**Brake Fluid Reservoir Warning Obscured –
New Brake Fluid Warning Label –
RECALL R171**

MODEL 2005 MY
S-TYPE
VIN N13089-N35567

RE: R-171 Recall - Brake Fluid Reservoir Warning Label

Brake Fluid Warning Label - Fitting Instructions

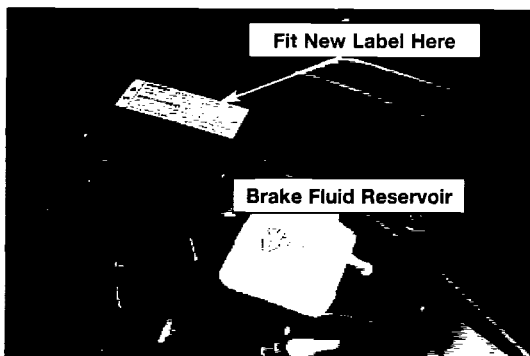
The leaf screen finisher located at the base of the windshield obscures the existing embossed warning on brake fluid reservoir. Therefore your vehicle is not in compliance with the Federal Motor Vehicle Safety Standard "FMVSS" 135 requirement. Additionally, there is a potential risk of using the incorrect specification brake fluid as a result of the warning statement being obscured. Using the incorrect brake fluid could affect the performance of your vehicles braking system. A listing of all recommended fluids can be found in your owner's handbook.

1. Open hood.
2. Locate the leaf screen finisher at the base of the windshield. (Above brake fluid reservoir)
3. Clean the area where the label is to be located using a suitable cleaner. (See photo below)
4. Remove paper backing and affix the new label to leaf screen finisher.
5. Repair Complete.
